Amendments to the Drawings:

Application No. 10/726,964
Amendment dated April 5, 2005
Reply to Office Action of January 7, 2005

FIG. 2

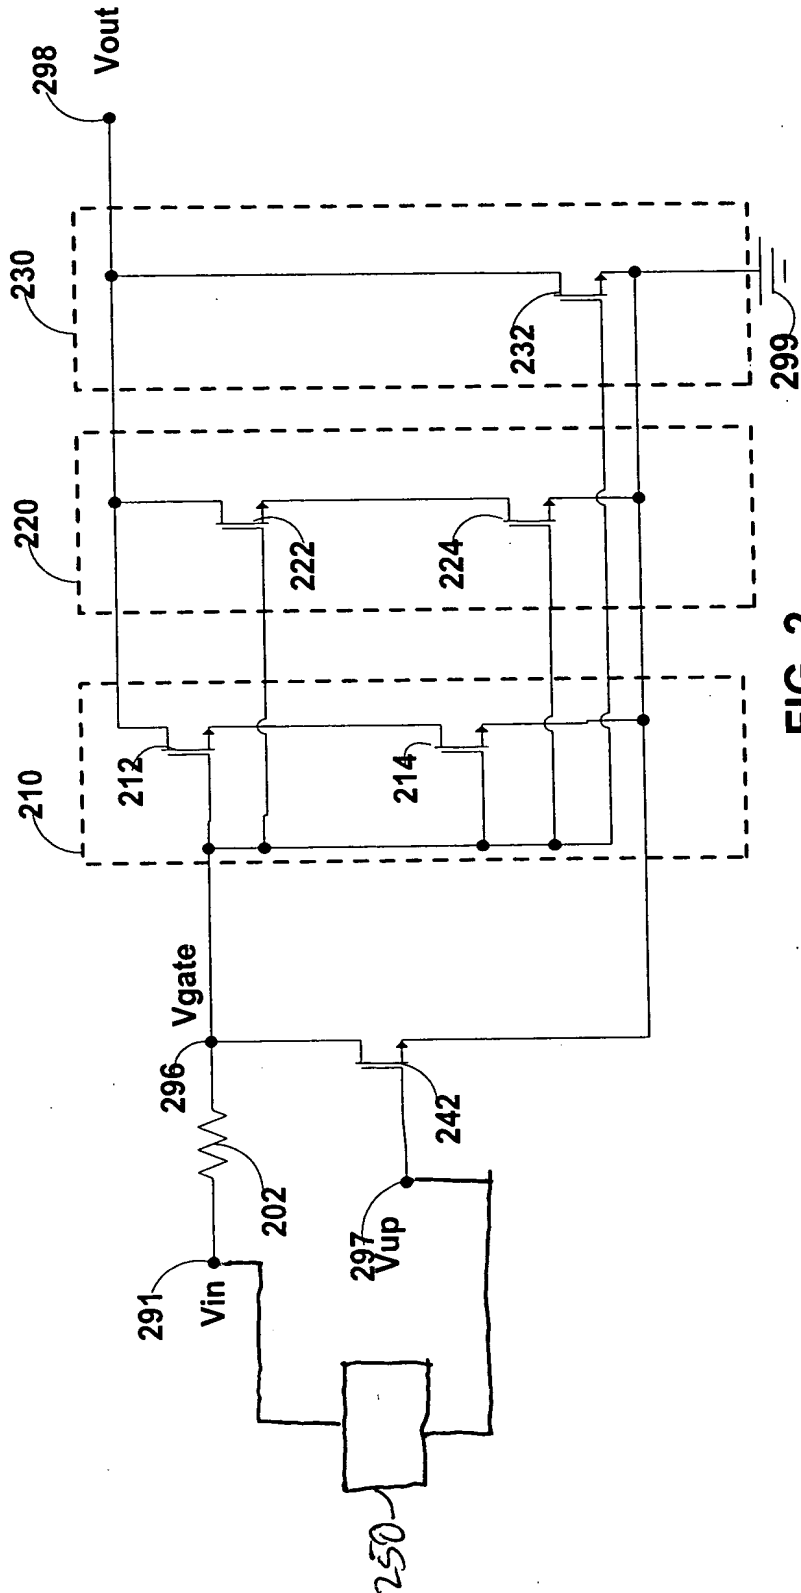
The drawings have been objected to under 37 C.F.R. § 1.83(a) for not showing every feature of the invention specified in claim 25.

The drawings have been objected to under 37 C.F.R. § 1.83(a) for not showing every feature of the invention specified in the claims, in particular the limitation of a comparator circuit of claim 25. The Examiner's objections are respectfully traversed.

FIG. 2 has been amended to correct inadvertent errors made by mistake and without deceptive intent. FIG. 2 has been amended to correlate with the specification and the originally filed claims. No new subject matter has been added. FIG. 2 has been amended such that the logical V_{UP} voltage on control node 297 is provided by the output of a comparator circuit 250 that compares the input voltage on node 291 with a minimum voltage required by a particular load. Support for the amendments appear in the specification at page 10, lines 6-11 and original claim 25, for example.

As described above, FIG. 2 has been amended to correct inadvertent errors made by mistake and without deceptive intent. FIG. 2 has been amended to correlate with the specification and the originally filed claims. No new subject matter has been added. FIG. 2 has been amended such that the logical V_{UP} voltage on control node 297 is provided by the output of a comparator circuit 250 that compares the input voltage on node 291 with a minimum voltage required by a particular load. Support for the amendments appear in the specification at page 10, lines 6-11, as amended, and original claim 25, for example.

Therefore, for at least the above reasons, FIG. 2 shows the limitation of a comparator circuit of claim 25. As such, applicants respectfully request that the objections of the drawings under 37 C.F.R. § 1.83(a) be withdrawn.
